UNITED STATES
DEPARTMENT OF THE INTERIOR
BUREAU OF LAND MANAGEMENT
APPLICATION FOR PERMIT TO DRILL OR REENTER

1a. Type of work: <input checked="" type="checkbox"/> DRILL <input type="checkbox"/> REENTER 1b. Type of Well: <input checked="" type="checkbox"/> Oil Well <input type="checkbox"/> Gas Well <input type="checkbox"/> Other 1c. Type of Completion: <input type="checkbox"/> Hydraulic Fracturing <input checked="" type="checkbox"/> Single Zone <input type="checkbox"/> Multiple Zone		5. Lease Serial No. NMNM0438001 6. If Indian, Allottee or Tribe Name 7. If Unit or CA Agreement, Name and No. 8. Lease Name and Well No. DEEP ELEM 4 FED COM 704H 9. API Well No. 30 015 48583

**EOG RESOURCES, INC.
DEEP ELEM 4 FED COM #704H**

Proposed Wellbore
Design A

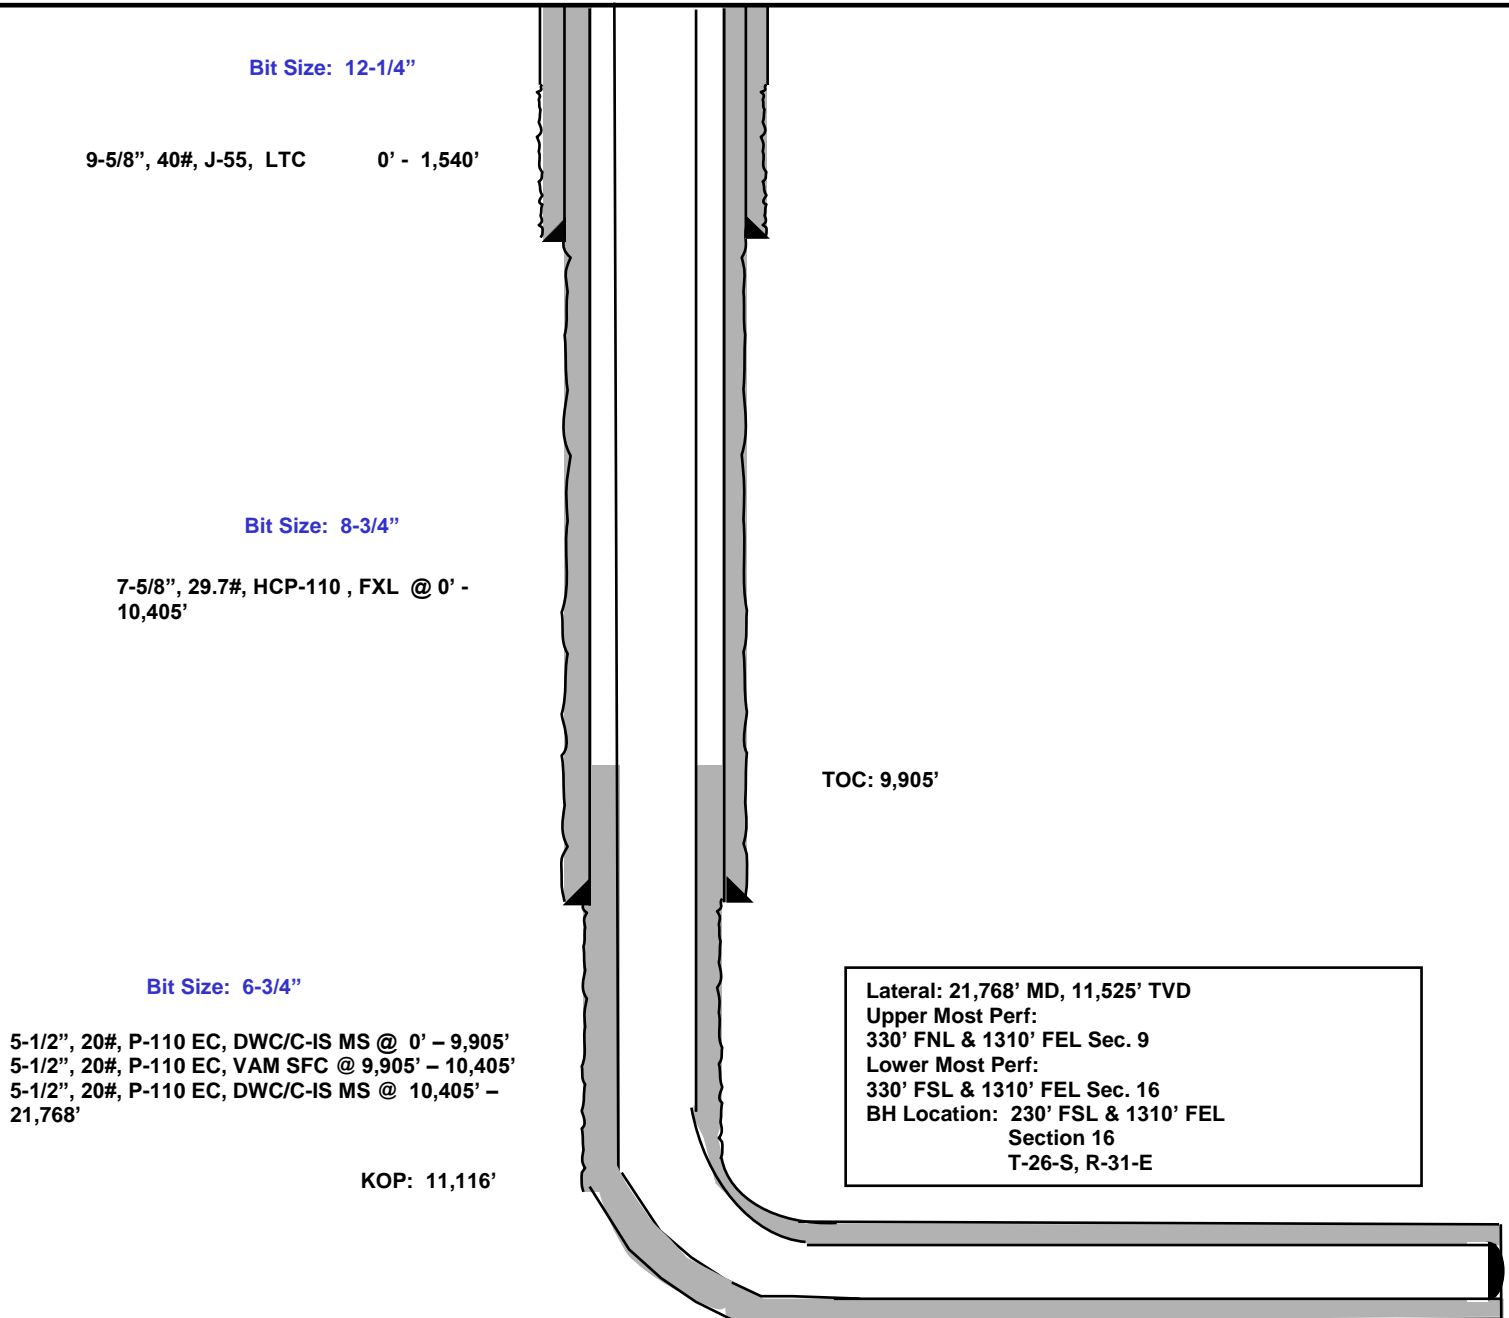
1. The **9-5/8** inch surface casing shall be set at approximately **1,275** feet (a minimum of **70 feet (Eddy County)** into the Rustler Anhydrite and above the salt) and cemented to the surface.
 - a. If cement does not circulate to the surface, the appropriate BLM office shall be notified and a temperature survey utilizing an electronic type temperature survey with surface log readout will be used or a cement bond log shall be run to verify the top of the cement. Temperature survey will be run a minimum of six hours after pumping cement and ideally between 8-10 hours after completing the cement job.

Operator has proposed to pump down 9-5/8" X 7-5/8" annulus. Operator must run Echo-meter to verify fluid top and the volume of displacement fluid above the cement slurry in the annulus.

3. The minimum required fill of cement behind the **5-1/2** inch production casing is:
 - Cement should tie-back at least **200 feet** into previous casing string. Operator shall provide method of verification.

Proposed Wellbore
Design B

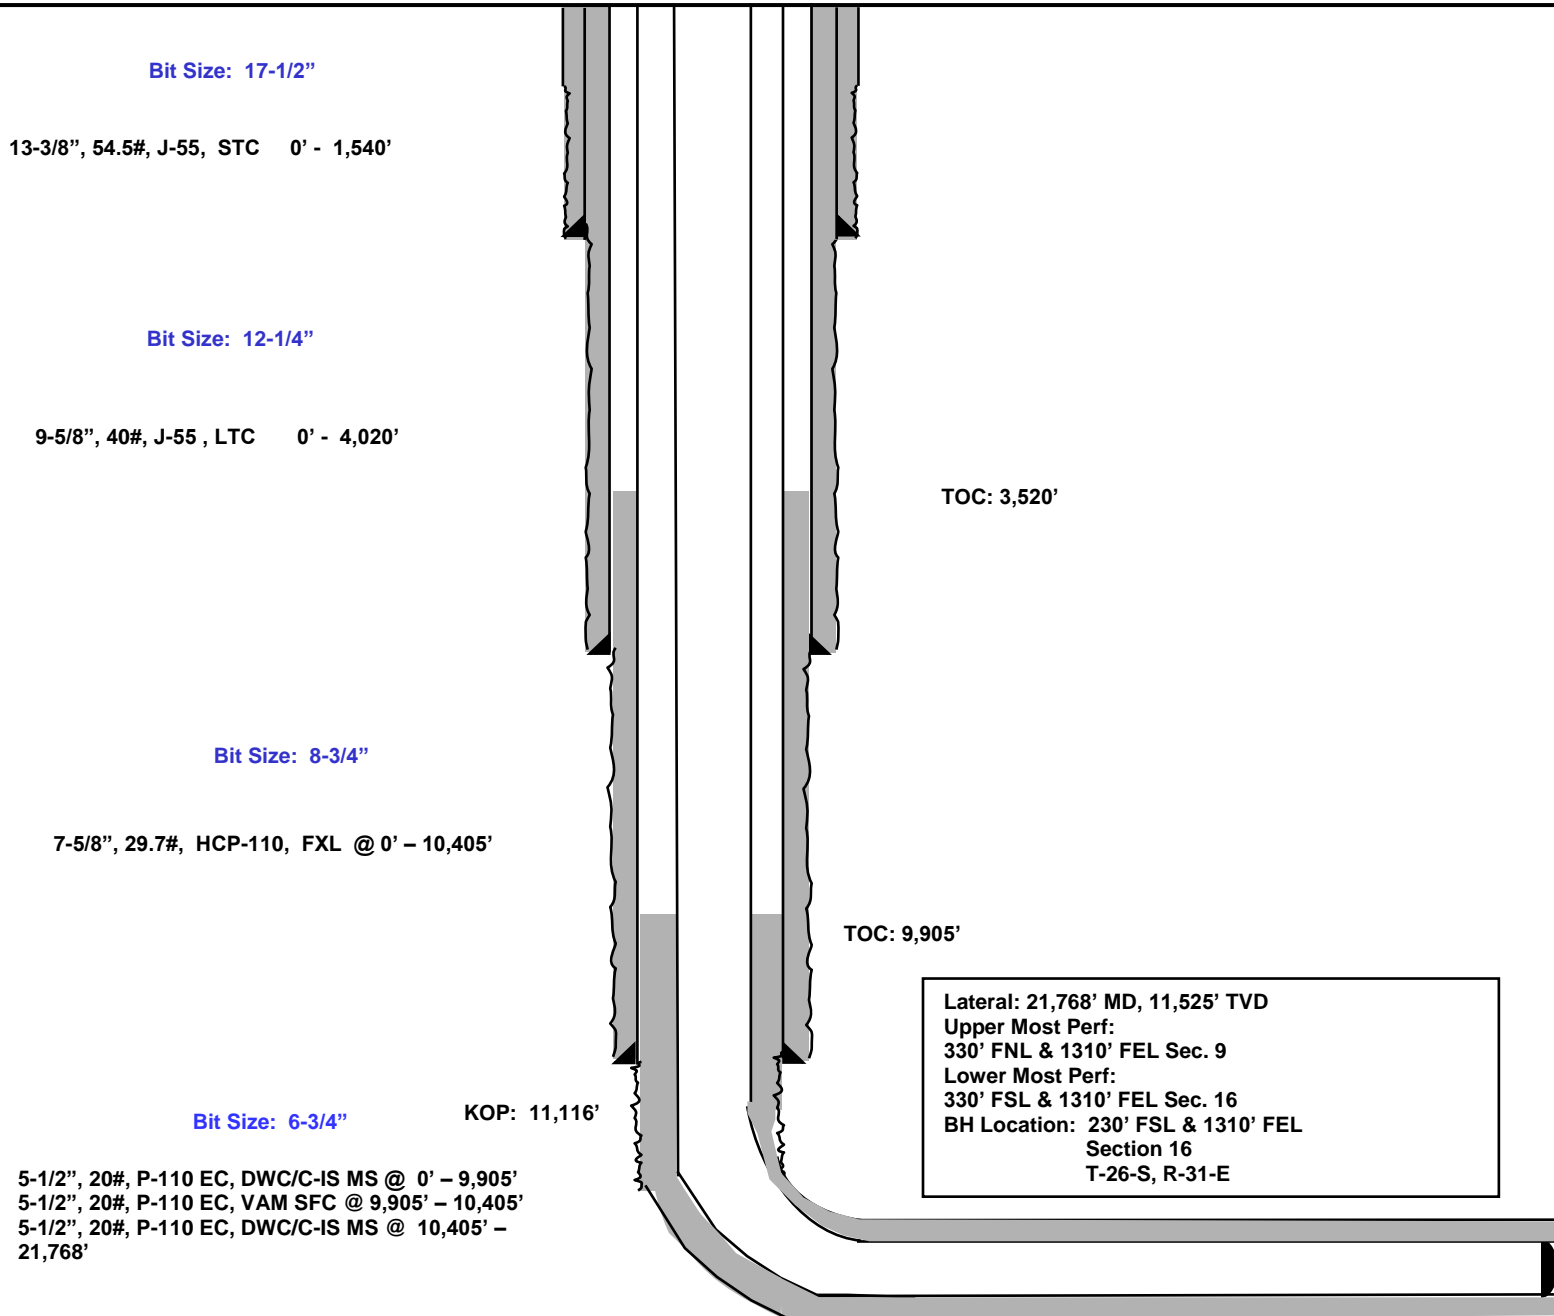
4. The **13-3/8** inch surface casing shall be set at approximately **1,275** feet (a minimum of **70 feet (Eddy County)** into the Rustler Anhydrite and above the salt) and cemented to the surface.
 - a. If cement does not circulate to the surface, the appropriate BLM office shall be notified and a temperature survey utilizing an electronic type temperature survey with surface log readout will be used or a cement bond log shall be run to verify the top of the cement. Temperature survey will be run a minimum of

- Operator will perform bradenhead squeeze. Cement should tie-back at least **200 feet** into previous casing string. Operator shall provide method of verification.

Operator has proposed to pump down 9-5/8" X 7-5/8" annulus. Operator must run Echo-meter to verify fluid top and the volume of displacement fluid above the cement slurry in the annulus.

7. The minimum required fill of cement behind the **5-1/2** inch production casing is:
- Cement should tie-back at least **200 feet** into previous casing string. Operator shall provide method of verification.
